RELEASE:	Title : SL-6132 TX Schematic
TOLERANCE: .XX: ± TOL-XX .XXX: ± TOL-XXX HOLE DIA.: ± TOL-DIA ANGLE: ± TOL-ANG	Heath Company Ltd.
MATERIAL:	DRAWN: Wilson 03/16/98 DATE; PART NO: W-32A-TX; REV: C
FINISH:	SCALE: ; PROJECTION: PROJN; SHEET: 1

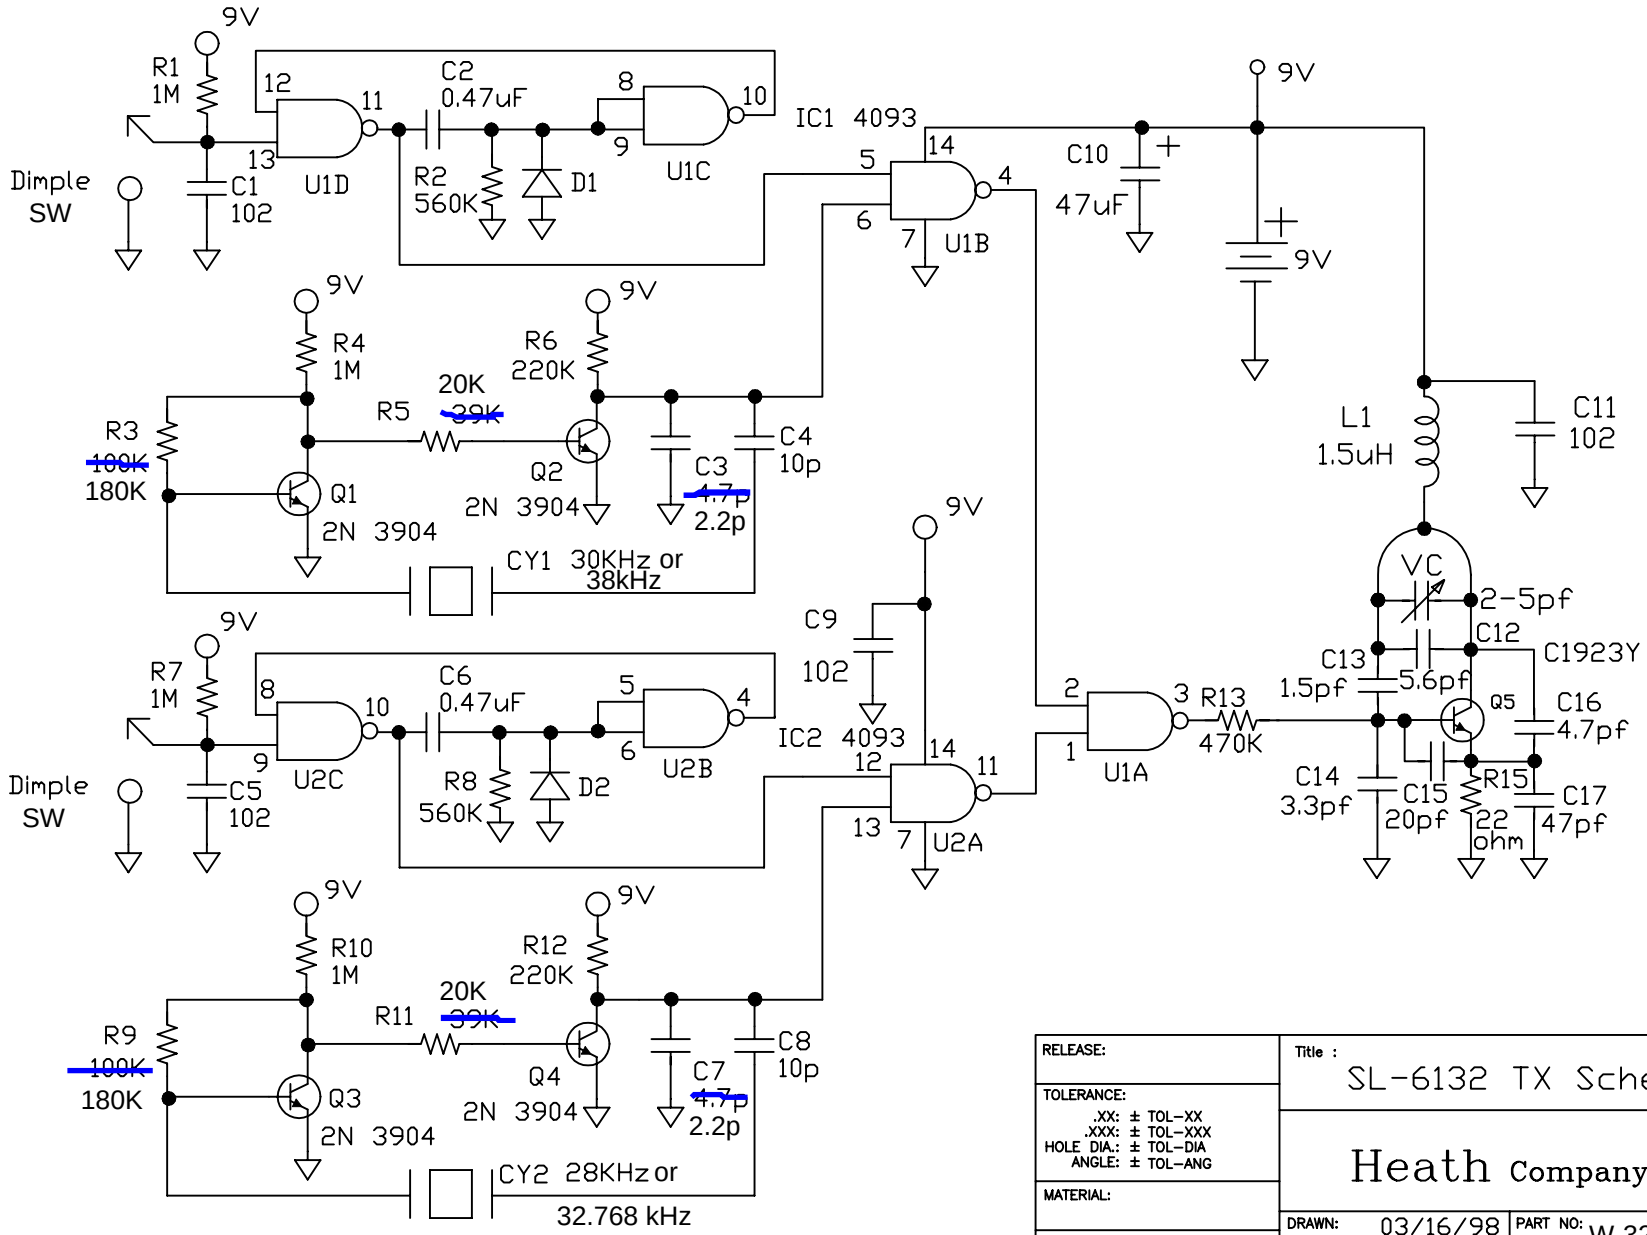
Rev	Description	Author	Date
Rev:C	The value of C13 is changed, was 3.3pf.	Wilson Chiu	06/16/98
Rev:B	The value of C2 and C6 are changed, were 47uf. The pin number of U1B output is corrected, was 4.	Wilson Chiu	05/28/98
Rev:A	The value of R13,C13,C14 are changed, were 120K, 2.2pf and 20pf respectively. R14 is deleted.	Wilson Chiu	05/27/98
